[Docket No. FAA-2006-24074; Directorate Identifier 2005-NM-213-AD]

Airworthiness Directives; Bombardier Model CL-600-2C10 (Regional Jet Series 700, 701, & 702) Airplanes, Model CL-600-2D15 (Regional Jet Series 705) Airplanes, and Model CL-600-2D24 (Regional Jet Series 900) Airplanes

ACTION: Notice of proposed rulemaking (NPRM).

Figure 1
LH side shown
RH side opposite

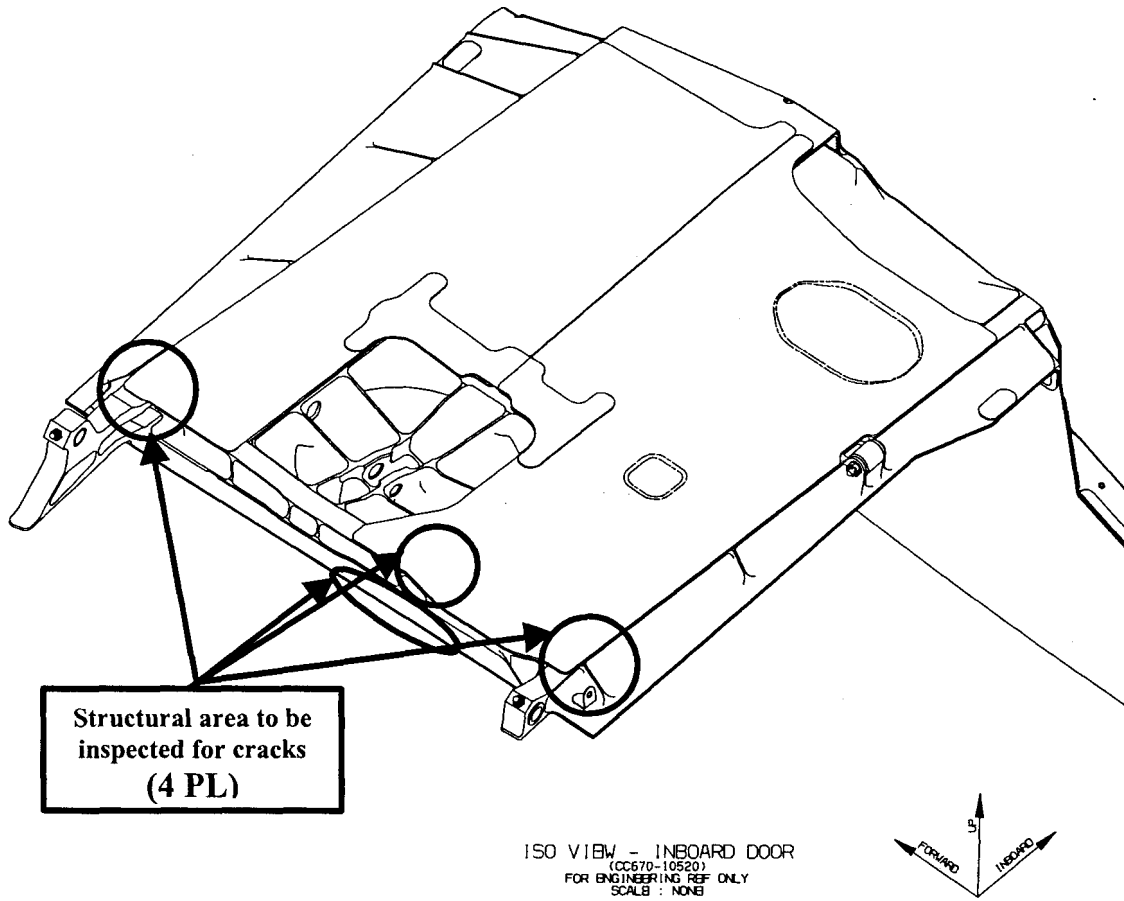
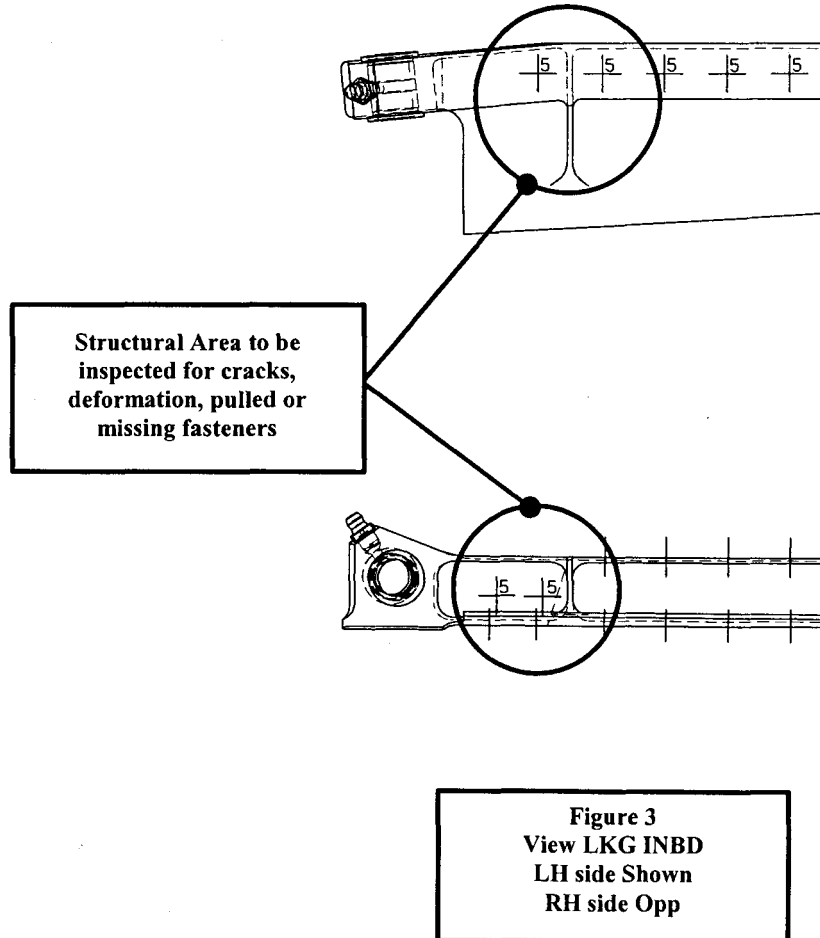
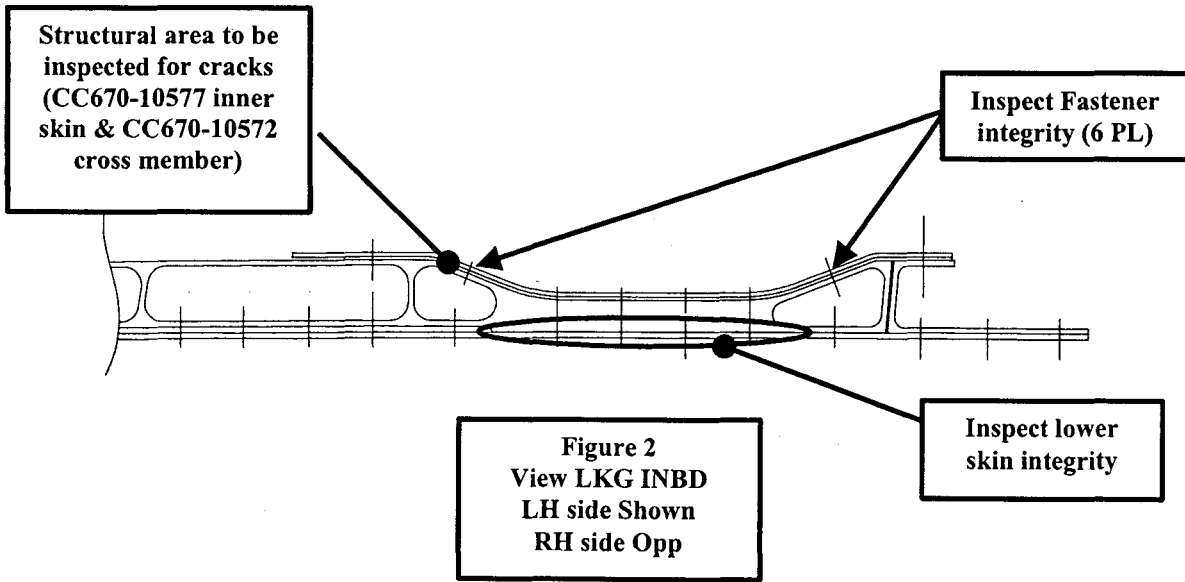
(g) For Model CL-600-2C10 (Regional Jet series 700 & 701) series airplanes, S/Ns 10003 through 10999 inclusive; and Model CL-600-2D24 (Regional Jet series 900) series airplanes, S/Ns 15002 through 15990 inclusive: At the applicable time specified in paragraph (f) of this AD, perform detailed inspections of the lower panel, part number (P/N) CC670-10520, of the left- and right-hand MLG doors for the conditions and in the areas specified in paragraphs (g)(1), (g)(2), (g)(3), and (g)(4) of this AD; and Figures 1, 2, and 3 of this AD.

(1) Inspect the cross member, P/N CC670-10572, of the MLG door lower panel for cracking or deformation, in accordance with Figure 2 of this AD.

cross member (P/N CC670-10572) for cracking or deformation, or pulled or missing fasteners, in accordance with Figure 2 of this AD.

(3) Inspect the outer skin, P/N CC670-10574, of the MLG door lower panel at the cross member (P/N CC670-10572) for cracking or deformation, or pulled or missing

(4) Inspect the forward member, P/N CC670-10570, and aft member, P/N CC670-10571, of the MLG door lower panel, for cracking or deformation, or pulled or missing fasteners, in accordance with Figure 3 of this AD. Figures 1 through 3 of this AD follow.
